File Reference: AC22032 – 04 – R1

Project: UWC Limited 64 Amberley Beach Road and 187 Carters Road, Amberley
Stages 3 – 6 ‘The Clearing’ Subdivision
Response to Minute 3

Re: Minute 3: Memorandum relating to acoustic questions and other matters

Figure 1 – May 2023 subdivision plan lot excerpt (with lot 257 – 258 omission)

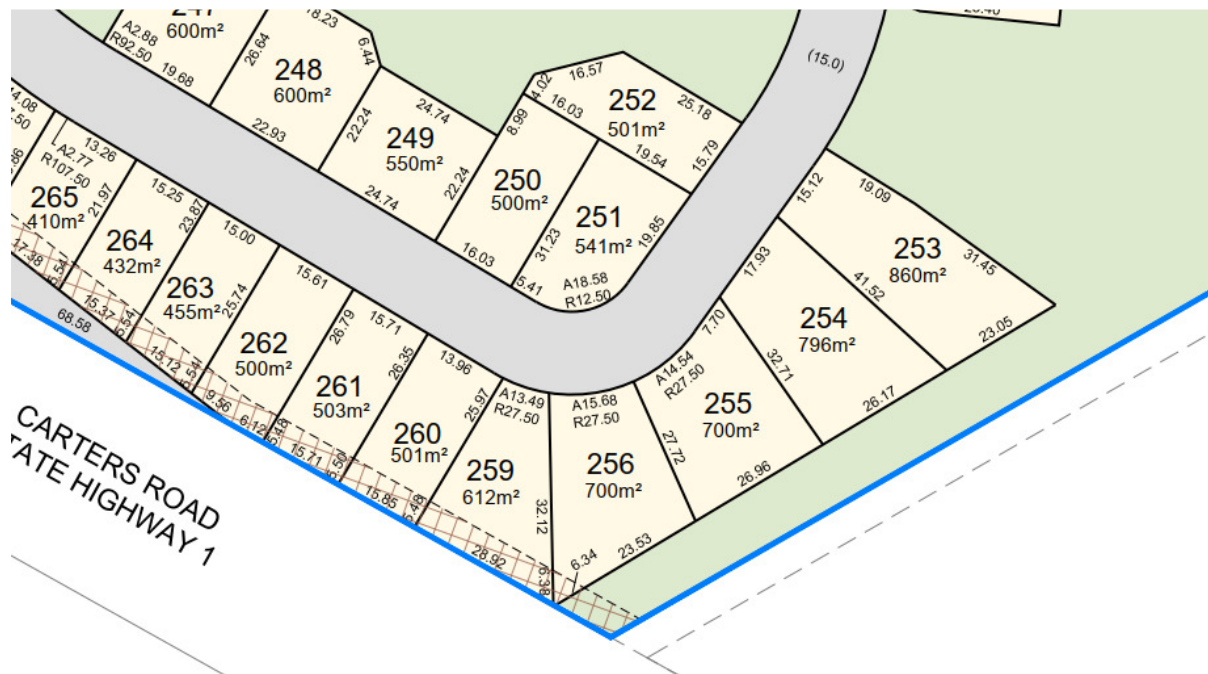
I note that the acoustic assessment which accompanied the application was based on the Master Plan titled *The Clearing – Stages 3 – 6 Proposed Development*, Issue H, as prepared by Davis Ogilvie & Partners, and dated February 2022. Compared to the latest scheme plan (May 2023), there have been some minor lot boundary position changes across roadside lots 253 – 259, as shown in figure 1 below. I also note that lots 257 and 258 are omitted. The layout updates are not expected to change any previous conclusions. Nonetheless, for the purposes of my response below, where there is a change in lot position/number, my response refers to the most recent plan.

Figure 2 – 57 dB $L_{Aeq}(24h)$ noise contour for 80 km/hr and 60 km/hr speed limits on SH1

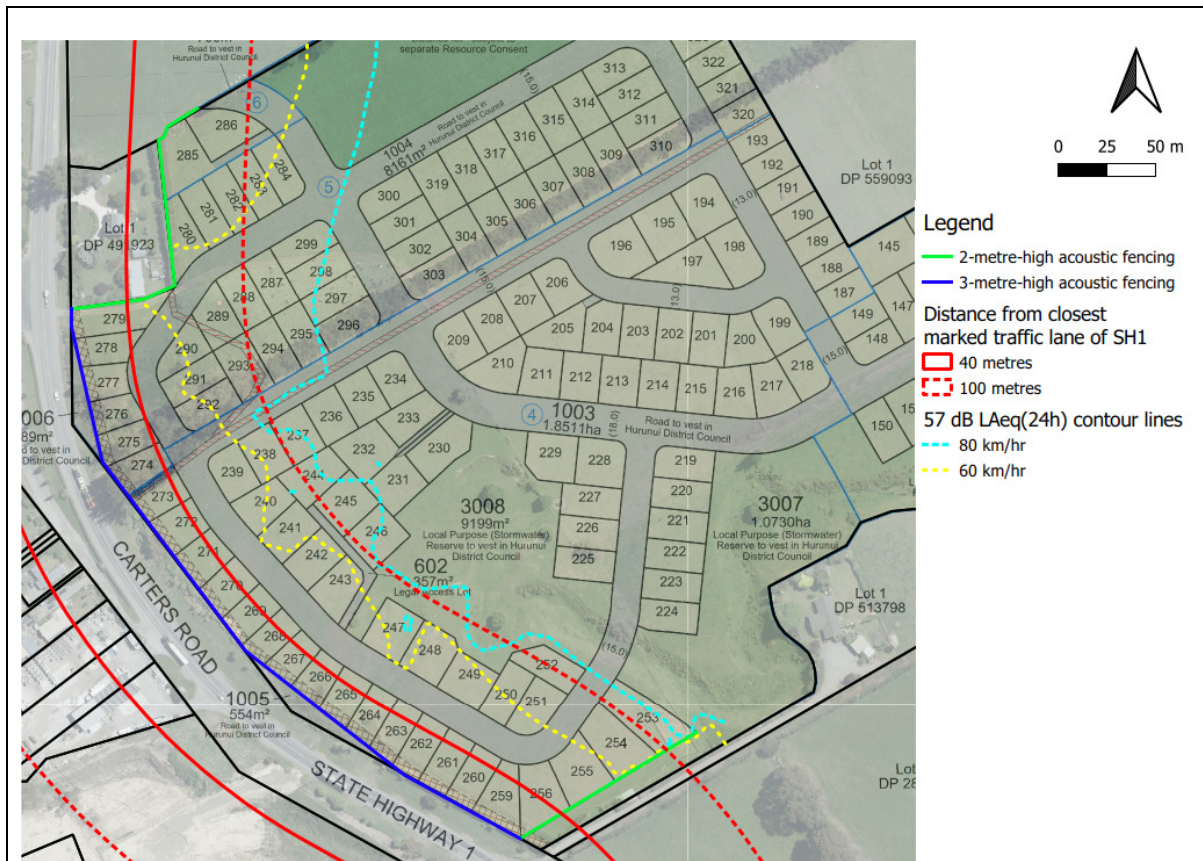
4vi	<p><i>In 4.2 reference is made to two-storey buildings potentially requiring “increased acoustic construction upgrades, more in line with those outlined in table 1”. Which are the lots potentially impacted by this?</i></p>
<p>The identified lots are:</p> <ul style="list-style-type: none"> 239 – 243 247 – 251 254 280 – 284 286 289 – 292 	
4vii	<p><i>To what extent would noise and vibration from SH1 reduce if the speed environment were reduced to 50 kph along the SH1 site frontage as is proposed if the retirement village intersection were constructed.</i></p>
<p><u>Noise</u></p> <p>I understand from email correspondence between Wayne Gallott (Novo Group Limited) and Damienne Donaldson (Davis & Ogilvie Ltd) that the current proposal for Carters Road is to retain the existing 50 km/hr to 80 km/hr speed limit change point just north of the planned new intersection, but with a change in speed limit from 80 km/hr to 60 km/hr from this location, to just south of the Grays Road intersection adjacent to the subdivision site. I have therefore assessed the expected effects if the speed limit were to be reduced to 60 km/hr instead of 50 km/hr.</p> <p>Based on a speed decrease to 60 km/hr, the following figure 2 below illustrates the difference or decrease in noise level across the subdivision with the change in speed limit on the State Highway adjacent to the subdivision.</p>

This shows that where the speed limit is reduced to 60 km/hr:

- Noise levels would decrease in the order of 1 – 2 dB $L_{Aeq}(24h)$ across the subdivision at the assessed lots.
- An estimated further 14 lots would receive noise levels of 57 dB $L_{Aeq}(24h)$ or less at ground floor level. Dwellings constructed on these lots would not require any mitigation controls (sound insulation upgrades) to ensure appropriate internal noise levels received within habitable spaces.

- All other lots within the buffer and effect zones (42 lots) may require slightly reduced acoustic sound insulation upgrades in order to meet the NZTA internal noise level requirements, compared to the situation where the speed limit is 80 km/hr, since the noise levels predicted to be incident on the façade of each dwelling may be slightly lower (by up to 2 dB). The extent of upgrades required will still be largely dependent on building design (i.e., building orientation, light-weight vs heavy construction elements, areas of glazing, and the like).

- We still recommend that two-storey buildings are not constructed on road-side lots 256 and 259 – 279, as the upper-level façade would receive noise levels in the order of 67 – 68 dB $L_{Aeq}(24h)$ since there is less attenuation provided by the acoustic bund/fence design. Two storey- dwellings are expected to require significant acoustic upgrades to the dwelling construction in order to meet NZTA internal noise level guidelines.
